**DOMINION ENERGY NUCLEAR CONNECTICUT, INC.**  
**MILLSTONE POWER STATION UNIT 3**  
**REVISED RESPONSES FOR TWO REQUEST FOR ADDITIONAL INFORMATION**  
**QUESTIONS FOR PROPOSED TECHNICAL SPECIFICATION CHANGES FOR**  
**SPENT FUEL POOL STORAGE AND NEW FUEL STORAGE**

**REVISED RESPONSES FOR TWO REQUEST FOR ADDITIONAL INFORMATION  
QUESTIONS FOR PROPOSED TECHNICAL SPECIFICATION CHANGES FOR  
SPENT FUEL STORAGE AND NEW FUEL STORAGE**

**MILLSTONE POWER STATION UNIT 3  
DOMINION ENERGY NUCLEAR CONNECTICUT, INC.**

**Figure 9.1 – KENO Region 2 6x6 Model**

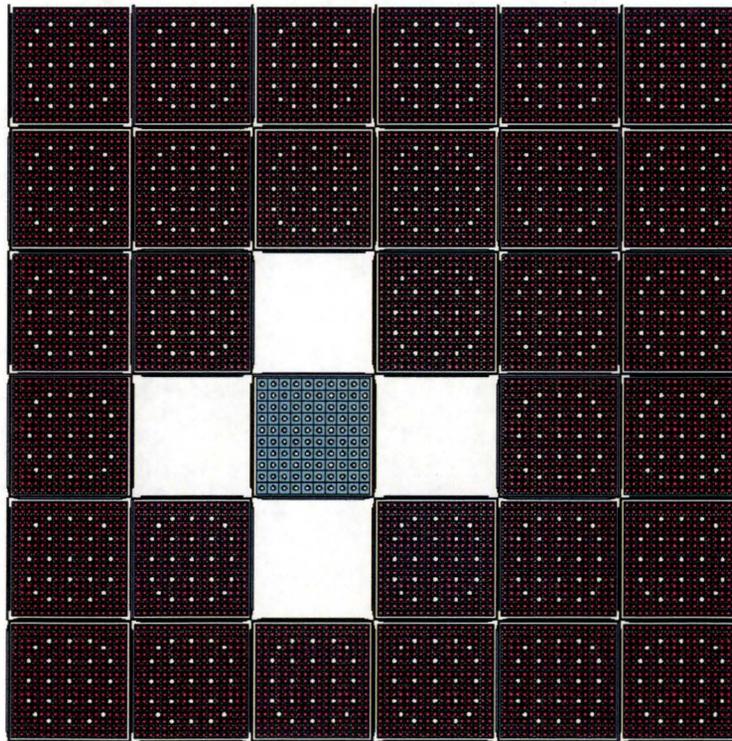
- a. *Region 1 wasn't explicitly modeled. Confirm that the requirement for storage cells that are face adjacent to the fuel assembly being reconstituted will also be applied to Region 1.*
- b. *The analysis did not address the number of fuel rod lattice locations that can be empty during the reconstitution process. Specify the number of fuel rod lattice locations that can be empty during the reconstitution process.*
- c. *The analysis addresses one fuel assembly with two empty fuel rod lattice locations. How would the licensee address other fuel assemblies with empty fuel rod lattice locations?*

With the reconstitution fuel assembly isolated, there is no limit on the number of empty fuel lattice locations. Confirmation is provided in Table 9.1. The Region 2 reconstitution model (LAR Attachment 5 / 6, Table 11.2) is modified by replacing the normal reconstitution fuel assembly near the center of the model with uniform pitch fuel lattices of varying number of fuel rods per side (maintaining the normal fuel assembly envelope) and, for some cases, varying rod pitch with the same reduced number of fuel rods. Varying the number of fuel rods and rod pitch will iteratively search for the optimum fuel to moderator ratio. KENO cases have no soluble boron and are run with moderator temperature set to 32°F. Figure 9.1 shows the configuration of the 100 fuel rod reconstitution model. Region 2 results were confirmed to also be valid for Region 3. As stated in RAI response 9a, Region 1 is bounded by Regions 2 and 3.
